Appendices

Appendix C: Facility Reports for City Buildings and Parks

Appendix D: Facility Reports for Downtown Parking Lots

Appendix E: Public Rights-of-Way Reports for City Facilities and Schools

City Hall
One North San Antonio Road
Los Altos, CA

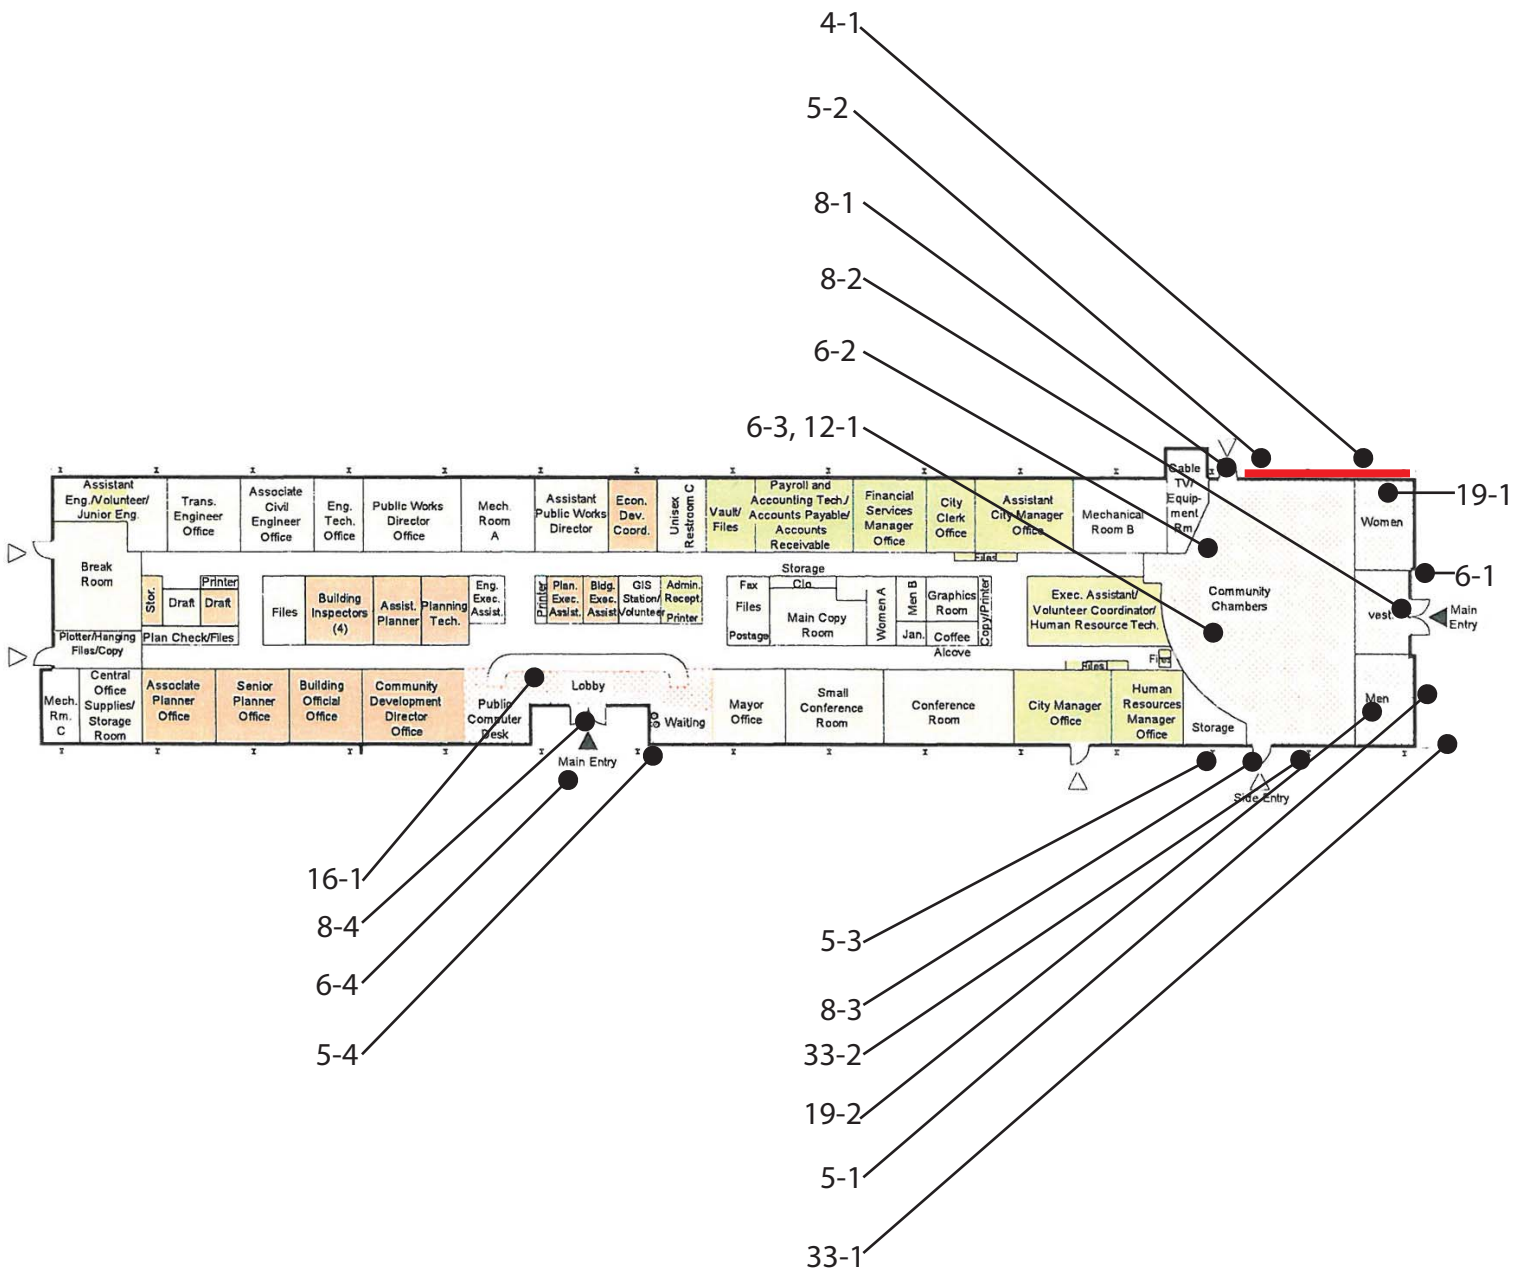
Exterior		
4 - 1	Walk	Priority: 1
Widen walk		\$5,100
Notes: Walkway to rear entrance is 51'-0" long. Width of walkway is 45" (48" min.) and there is a 5" drop off near ramp (4" max.)		
State: 1133B.7.1		
Federal: -		
5 - 1	Ramp	Priority: 1
Provide level landing		\$5,000
Notes: Bottom landing is 67" (72" min.) Slope at bottom landing is 6% (2% max.)		
State: 1133B.5.4.6		
Federal: -		
Install or modify handrails		\$5,000
Notes: Top and bottom handrail extensions are not provided. Height to top of handrail is 33" above grade (34-38" req.)		
State: 1133B.5.5.1		
Federal: 505.10.1, 505.4		
5 - 2	Ramp	Priority: 1
Regrade or replace ramp		\$25,000
Notes: Ramp is 43-1/2" wide (48" min.) Ramp is 10'-0" long.		
State: 1133B.5.2		
Federal: 405.5		
Install warning curb		\$1,500
Notes: A 2" wheel guide is not provided.		
State: 1133B.5.6		
Federal: 405.9		
Install or modify handrails		\$5,000
Notes: Handrail gripping surface is 5-1/4" (1-1/4-1-1/2" req.)

Exterior		
5 - 3	Ramp	Priority: 1
Provide level landing		\$5,000
Notes: Door in open position reduces top landing width to 54" (42" + width of door = 57" min.). Bottom landing is 62" (72" min.)		
State: 1133B.4.4, 1133B.5.4.6		
Federal: 405.7.5		
Install warning curb		\$1,500
Notes: Wheel guide is not provided.		
State: 1133B.5.6		
Federal: 405.9		
Regrade or replace ramp		\$50,000
Notes: Width of ramp is 41-3/4" (48" min.) The ramp is 16'-0" long.		
State: 1133B.5.2		
Federal: 405.5		
5 - 4	Ramp	Priority: 1
Regrade or replace ramp		\$30,000
Notes: Ramp width is 41" (48" min.). The ramp is 17'-0" long.		
State: 1133B.5.2		
Federal: 405.5		
Install or modify handrails		\$5,000
Notes: Handrail is provided on one side only. There is no top or bottom extension.		
State: 1133B.5.5.1		
Federal: 405.8, 505.10.1, 505.4		
6 - 1	Stairway	Priority: 1
Install tread striping		\$75
Notes: Indicator stipes are not provided. Stair has three risers.

Exterior		
6 - 4	Stairway	Priority: 1
Replace stairs		\$15,000
Notes: Riser heights are not uniform.		
State: 1133B.4.5		
Federal: 504.2		
Install tread striping		\$50
Notes: Indicator stripes are not provided. There are two risers.		
State: 1133B.4.4		
Federal: -		
Install or modify handrails		\$5,000
Notes: Handrails are provided on one side only. Top and bottom extensions are not provided.		
State: 1133B.4.2.2, 1133B4.1.1		
Federal: 505.10.2, 505.2		
33 - 1	Outdoor Constructed Features	Priority: 2
Increase or provide maneuvering or clear floor area		\$2,000
Notes: Companion seating is not provided. There is no back to the bench.		
State: -		
Federal: AGODA 1011.2.1		
33 - 2	Outdoor Constructed Features	Priority: 2
Increase or provide maneuvering or clear floor area		\$2,000
Notes: Companion seating is not provided. There is no back to the bench.		
State: -		
Federal: AGODA 1011.2.1

Floor 1		
6 - 2	Stairway	Priority: 2
Install tread striping		\$50
Notes: Indicator stripes are not provided on the first and last riser.		
State: 1133B.4.4		
Federal: -		
Install or modify handrails		\$5,000
Notes: Handrails are not provided.		
State: 1133B.4.2.1, 1133B.4.2.2, 1133B.4.2.5, 1133B.4.2.6, 1133B4.1.1		
Federal: 505.10.2, 505.2, 505.4, 505.5, 505.9		
Replace stairs		\$20,000
Notes: Stair width is 34-1/2" (44" min.) There are two risers. There is no accessible path of travel to the dias.		
State: 1009.1		
Federal: -		
6 - 3	Stairway	Priority: 2
Install tread striping		\$50
Notes: Indicator stripes are not provided on the first and last riser.		
State: 1133B.4.4		
Federal: -		
Install or modify handrails		\$0
Notes: Handrails are not provided.		
State: 1133B.4.2.1, 1133B.4.2.2, 1133B.4.2.5, 1133B.4.2.6, 1133B4.1.1		
Federal: 505.10.2, 505.2, 505.4, 505.5, 505.9		
Replace stairs		\$0
Notes: Stair width is 34-1/2" (44" min.) There are two risers.

State: 1009.1		
Federal: -		
8 - 1	Door/Gate	Priority: 1
Adjust door closer		\$250
Notes: Two sets of double doors at Council Chambers entrance. Operating effort ranges from 8-11lbs. (5lbs max.)		
State: 1133B.2.5		
Federal: 404.2.9		
Provide sign(s) indicating accessible entries and facilities		\$1,000
Notes: Two sets of double doors at Council Chambers entrance are not marked with International Symbol of Accessibility.		
State: 1117B.5.8.1.2		
Federal: 216.6, 703.7.2.1

Floor 1		
8 - 2	Door/Gate	Priority: 1
Install or modify permanent room signs		\$250
Notes: Braille EXIT sign is not provided.		
State: -		
Federal: 1011.3		
Provide or modify door kickplate		\$1,000
Notes: Door stop on kick plate.		
State: 1133B.2.6		
Federal: 404.2.10		
Provide additional strike edge clearance		\$5,000
Notes: Strike edge clearance on swing side of door is 21" (24" min.). Strike edge clearance on push side is 6" (12" min.)		
State: 1133B.2.4.2		
Federal: 404.2.4.1		
Adjust door closer		\$250
Notes: Operating effort is 17lbs (5lbs max.)		
State: 1133B.2.5		
Federal: 404.2.9		
8 - 3	Door/Gate	Priority: 1
Install or modify permanent room signs		\$250
Notes: Braille EXIT sign is not provided.		
State: -		
Federal: 1011.3		
Provide additional strike edge clearance		\$5,000
Notes: Strike edge clearance on swing side of door is 22" (24" min.). Strike edge clearance on push side is 7" (12" min.)		
State: 1133B.2.4.2

Floor 1		
8 - 4	Door/Gate	Priority: 1
Provide sign(s) indicating accessible entries and facilities		\$1,000
Notes: Primary entrance is not marked with International Symbol of Accessibility.		
State: 1117B.5.8.1.2		
Federal: 216.6, 703.7.2.1		
Adjust door closer		\$250
Notes: Operating effort is 6lbs (5lbs max.)		
State: 1133B.2.5		
Federal: 404.2.9		
12 - 1	Building Level / Lift	Priority: 2
Install ramp or lift		\$35,000
Notes: Install ramp or lift up to the Council dias.		
State: 1120B.1		
Federal: 206.2.3		
16 - 1	Built-in Elements	Priority: 2
Provide an accessible counter		\$7,500
Notes: Front counter is 41-3/4" AFF (btwn. 28-34" req.)		
State: 1122B.4		
Federal: -

Floor 1		
19 - 1	Multiple User Restroom	Priority: 2
Install sign		\$500
Notes: Federal signage is not provided on the latch side of the restroom door.		
State: -		
Federal: 703		
Replace or reposition dispensers or mirrors		\$300
Notes: Paper towel dispenser is located 43" AFF (40" max.) Toilet paper dispenser is located 11" in front of the toilet. (7-9" req.)		
State: 1115B.8.3, 1115B.8.4		
Federal: 604.7		
Modify lavatory/counter clearances		\$2,500
Notes: Lavatory is 16" from the wall (18" min.)		
State: 1115B.4.3		
Federal: -		
Provide additional strike edge clearance		\$5,000
Notes: Strike edge clearance on the swing side of the compartment door is 7" (18" min.)		
State: 1115B.3.1.4		
Federal: -		
Provide or replace stall door hardware		\$250
Notes: There is not loop shaped handle on the inside of the compartment door.		
State: 1115B.3.1.4		
Federal: 604.8.1.2		
Reposition clothing hooks		\$100
Notes: Coat hook on compartment door is located 65" AFF (48" max.)

State: 1118B.5		
Federal: -		
Replace or modify grab bars		\$1,000
Notes: Grab bars are located 34" AFF (33" max.) and overall length of side grab bar is 49-1/2" (54" min.)		
State: 1115B.4.1.3		
Federal: -		
Reposition toilet flush controls		\$1,000
Notes: Toilet flush control is not on the wide side of the compartment.		
State: 1115B.4.1.5		
Federal: 604.6

Floor 1		
19 - 2	Multiple User Restroom	Priority: 2
Install sign		\$500
Notes: Federal signage is not provided on the latch side of the restroom door.		
State: -		
Federal: 703		
Replace or reposition dispensers or mirrors		\$300
Notes: Paper towel dispenser is located 43" AFF (40" max.) Toilet paper dispenser is located 11" in front of the toilet. (7-9" req.)		
State: 1115B.8.3, 1115B.8.4		
Federal: 604.7		
Modify lavatory/counter clearances		\$2,500
Notes: Lavatory is 16" from the wall (18" min.)		
State: 1115B.4.3		
Federal: -		
Provide additional strike edge clearance		\$5,000
Notes: Strike edge clearance on the swing side of the compartment door is 7" (18" min.)		
State: 1115B.3.1.4		
Federal: -		
Provide or replace stall door hardware		\$250
Notes: There is not loop shaped handle on the inside of the compartment door. Door is not self closing.		
State: 1115B.3.1.4		
Federal: 604.8.1.2		
Reposition clothing hooks		\$100

Notes: Coat hook on compartment door is located 66" AFF (48" max.)		
State: 1118B.5		
Federal: -		
Replace or modify grab bars		\$1,000
Notes: Grab bars are located 34" AFF (33" max.) and overall length of side grab bar is 49" (54" min.)		
State: 1115B.4.1.3		
Federal: -

Egan Gym
100 W. Portola Avenue
Los Altos, CA

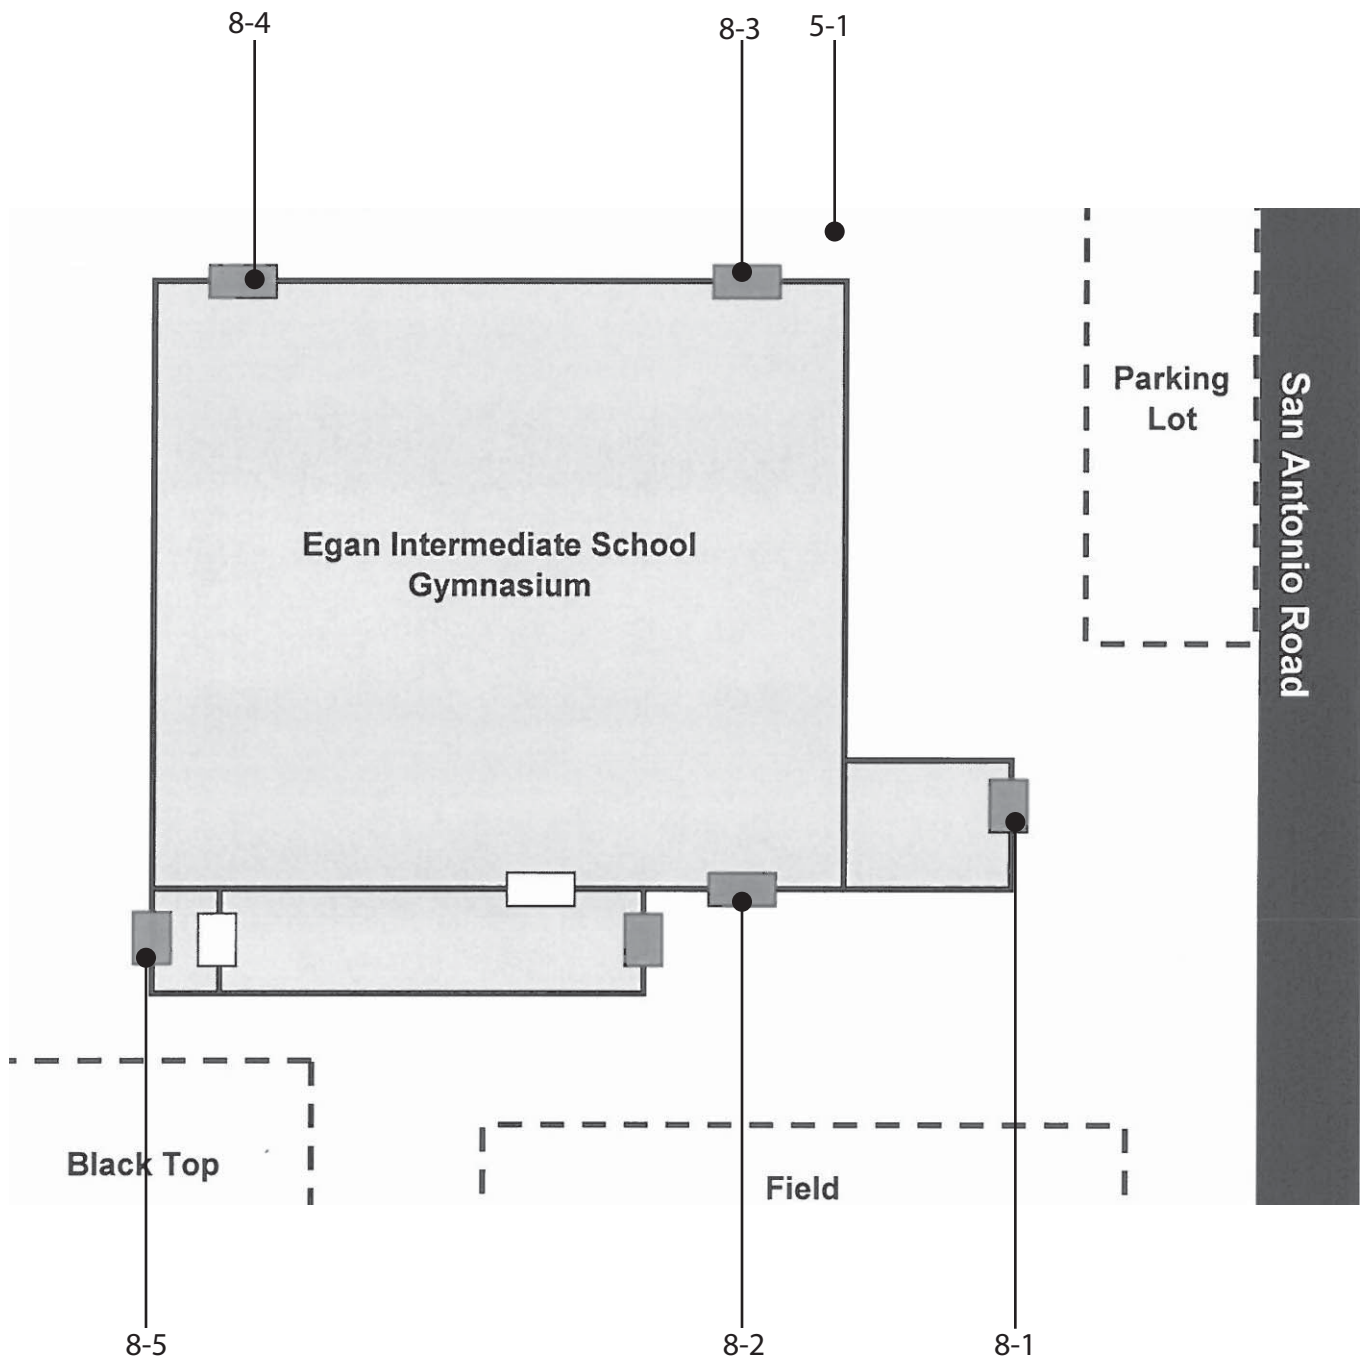
Exterior		
5 - 1	Ramp	Priority: 1
Install or modify handrails		\$5,000
Notes: Bottom extension of handrails are not provided.		
State: 1133B.5.5.1		
Federal: 505.10.1		
Regrade or replace ramp		\$15,000
Notes: Ramp has a slope of 9% near the base of the ramp. The bottom landing has cross slopes that exceed 2%. The ramp is 28'-0" long.		
State: 1133B.5.3		
Federal: 405.2

Floor 1		
8 - 1	Door/Gate	Priority: 1
Adjust door closer		\$250
Notes: Operating effort is 10-14lbs for both doors. (5lbs max.)		
State: 1133B.2.5		
Federal: 404.2.9		
Install or modify permanent room signs		\$250
Notes: Braille EXIT sign is not provided.		
State: -		
Federal: 1011.3		
Provide sign(s) indicating accessible entries and facilities		\$1,000
Notes: The designated accessible entrance is not marked with the International Symbol of Accessibility.		
State: 1117B.5.8.1.2		
Federal: 216.6, 703.7.2.1		
8 - 2	Door/Gate	Priority: 2
Adjust door closer		\$250
Notes: Operating effort is 9-10lbs for both doors. (5lbs max.)		
State: 1133B.2.5		
Federal: 404.2.9		
Install or modify permanent room signs		\$250
Notes: Braille EXIT sign is not provided.		
State: -		
Federal: 1011.3		
8 - 3	Door/Gate	Priority: 1
Adjust door closer		\$250
Notes: Operating effort is 9-10lbs for both doors. (5lbs max.)		
State: 1133B.2.5

Floor 1		
8 - 4	Door/Gate	Priority: 1
Adjust door closer		\$250
Notes: Operating effort is 10-30lbs for both doors. (5lbs max.)		
State: 1133B.2.5		
Federal: 404.2.9		
Install or modify permanent room signs		\$250
Notes: Braille EXIT sign is not provided.		
State: -		
Federal: 1011.3		
8 - 5	Door/Gate	Priority: 1
Adjust door closer		\$250
Notes: Operating effort is 12-15lbs for both doors. (5lbs max.)		
State: 1133B.2.5		
Federal: 404.2.9		
Install or modify permanent room signs		\$250
Notes: Braille EXIT sign is not provided.		
State: -		
Federal: 1011.3

Garden House
400 University Avenue
Los Altos, CA

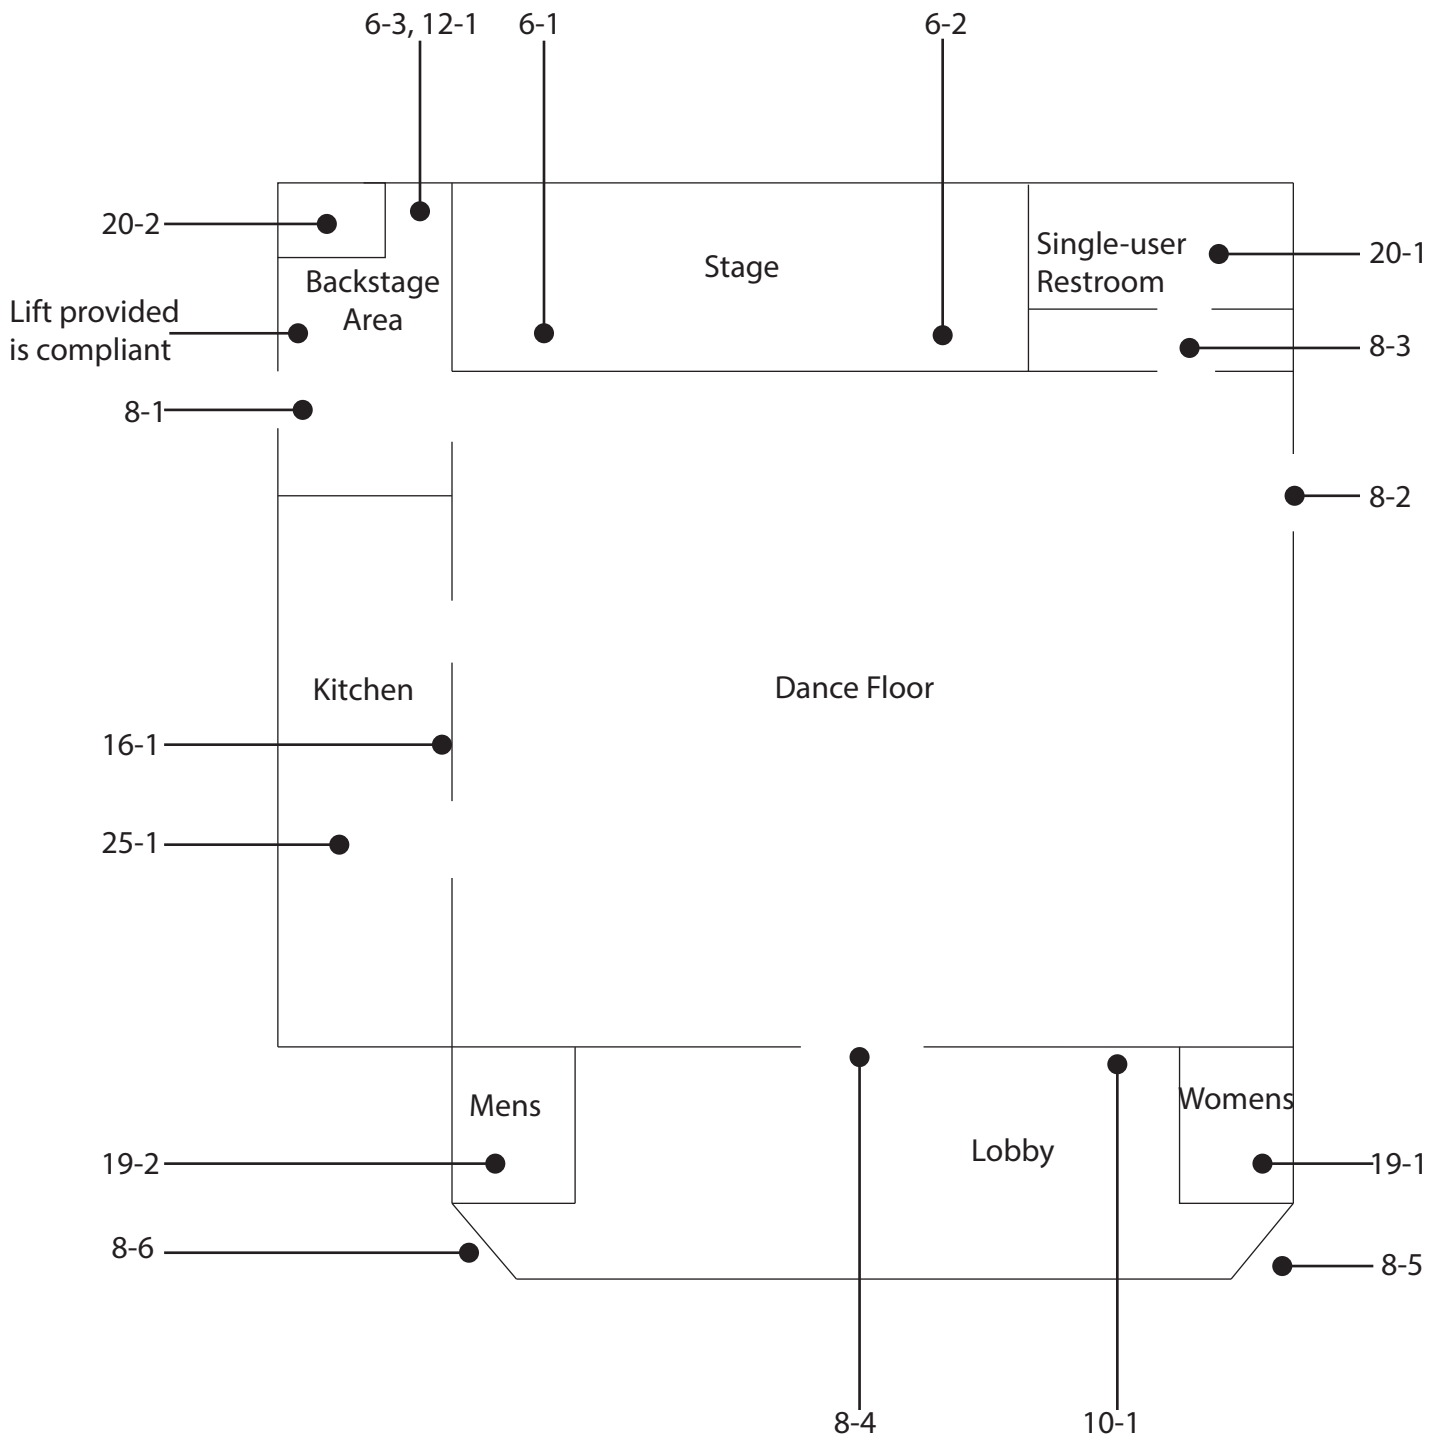
Floor 1		
6 - 1	Stairway	Priority: 2
Install or modify handrails		\$5,000
Notes:	Handrail is provided on one side only. Handrail is mounted 32" AFF (34-38" req.) Top and bottom extensions are not provided.	
State:	1133B.4.2.1, 1133B.4.2.2, 1133B4.1.1	
Federal:	505.10.2, 505.2, 505.4	
6 - 2	Stairway	Priority: 2
Install or modify handrails		\$5,000
Notes:	Handrail is provided on one side only. Handrail is mounted 32" AFF (34-38" req.) Top and bottom extensions are not provided.	
State:	1133B.4.2.1, 1133B.4.2.2, 1133B4.1.1	
Federal:	505.10.2, 505.2, 505.4	
6 - 3	Stairway	Priority: 2
Install or modify handrails		\$5,000
Notes:	Handrails are mounted 32" AFF (btwn 28-34" req.) Top and bottom extensions are not provided.	
State:	1133B.4.2.1, 1133B.4.2.2	
Federal:	505.10.2, 505.4	
Replace stairs		\$25,000
Notes:	Stair width is 41" (44" min.)	
State:	1009.1	
Federal:	-

Floor 1		
8 - 1	Door/Gate	Priority: 1
Provide or modify door kickplate		\$500
Notes: Door stop in kick plate.		
State: 1133B.2.6		
Federal: 404.2.10		
Adjust door closer		\$250
Notes: Operating effort is 17lbs (5lbs max.)		
State: 1133B.2.5		
Federal: 404.2.9		
Enlarge door opening		\$5,000
Notes: Height of clear opening of the door is 78" (80" min.)		
State: 1133B.2.2		
Federal: -		
Install or modify permanent room signs		\$250
Notes: Braille EXIT signage is not provided.		
State: -		
Federal: 1011.3		
Provide additional strike edge clearance		\$5,000
Notes: Strike edge clearance on the swing side is 9" (18" min.) on the push side 6-1/2" (12" min.)		
State: 1133B.2.4.2		
Federal: 404.2.4.1		
8 - 2	Door/Gate	Priority: 1
Adjust door closer		\$250
Notes: Operating effort is 17lbs (5lbs max.)		
State: 1133B.2.5		
Federal: 404.2.9		
Replace or modify door threshold		\$1,500
Notes: Threshold is 3-1/2" (1/2" max.)		
State: 1133B.2.4.1

Federal: 404.2.5		
8 - 3	Door/Gate	Priority: 2
Replace or adjust door hardware		\$500
Notes: Door knob requires grasping and twisting.		
State: 1133B.2.5.2		
Federal: 309.4

Floor 1		
8 - 4	Door/Gate	Priority: 2
Provide or modify door kickplate		\$500
Notes: Door stop is located in the kick plate.		
State: 1133B.2.6		
Federal: 404.2.10		
Enlarge door opening		\$5,000
Notes: Double doors. Height of the clear opening is 78" to the door closer. (80" min.)		
State: 1133B.2.2		
Federal: -		
Install or modify permanent room signs		\$250
Notes: Braille EXIT signage is not provided.		
State: -		
Federal: 1011.3		
8 - 5	Door/Gate	Priority: 1
Adjust door closer		\$250
Notes: Operating effort is 27lbs for both doors (5 lbs max.)		
State: 1133B.2.5		
Federal: 404.2.9		
Provide or modify door kickplate		\$500
Notes: Door stop is mounted in the kick plate.		
State: 1133B.2.6		
Federal: 404.2.10		
Enlarge door opening		\$5,000
Notes: Door opening is 78" to the closer (80" min.). Double doors.		
State: 1133B.2.2		
Federal: -		
Replace or modify door threshold		\$1,500
Notes: Threshold is 1-3/4" (1/2" max.)

Floor 1		
8 - 6	Door/Gate	Priority: 1
Adjust door closer		\$250
Notes: Operating effort for both doors is 18lbs (5lbs max.)		
State: 1133B.2.5		
Federal: 404.2.9		
Provide or modify door kickplate		\$500
Notes: Door stop is mounted to kick plate for one of the two doors.		
State: 1133B.2.6		
Federal: 404.2.10		
Replace or modify door threshold		\$1,500
Notes: Threshold is 1-3/4" (1/2" max.)		
State: 1133B.2.4.1		
Federal: 404.2.5		
10 - 1	Drinking Fountain	Priority: 3
Adjust water stream		\$100
Notes: Controls to operate drinking fountain require grasping and twisting.		
State: 1117B.6.4		
Federal: 309		
12 - 1	Building Level / Lift	Priority: 1
Install ramp or lift		\$35,000
Notes: Lift needs to be provided to access stage area.		
State: 1120B.1		
Federal: 206.2.3		
16 - 1	Built-in Elements	Priority: 2
Provide an accessible counter		\$5,000
Notes: Counter near kitchen is located 36" AFF (btwn. 28-34" req.)		
State: 1122B.4

Floor 1		
19 - 2	Multiple User Restroom	Priority: 2
Install sign		\$500
Notes: Install signage to indicate the location of 20-1.		
State: 1117B.1		
Federal: 216.8		
20 - 1	Single User Restroom	Priority: 2
Install sign		\$500
Notes: Sign is centered 58" on the door (60" req.)		
State: 1115B.6		
Federal: -		
20 - 2	Single User Restroom	Priority: 4
Provide an accessible path of travel		\$25,000
Notes: Single user restroom is backstage area is not accessible.		
State: 1114B.1.2		
Federal: 206.2		
Install sign		\$500
Notes: Install signage to indicate the location of 20-1.		
State: 1115B.1		
Federal: 216.8		
25 - 1	Kitchen	Priority: 2
Modify lavatory/counter clearances		\$5,000
Notes: Knee space beneath the sink is not provided. Counter height is 35" AFF (btwn. 28-34")		
State: 1117B.9		
Federal: 804.4
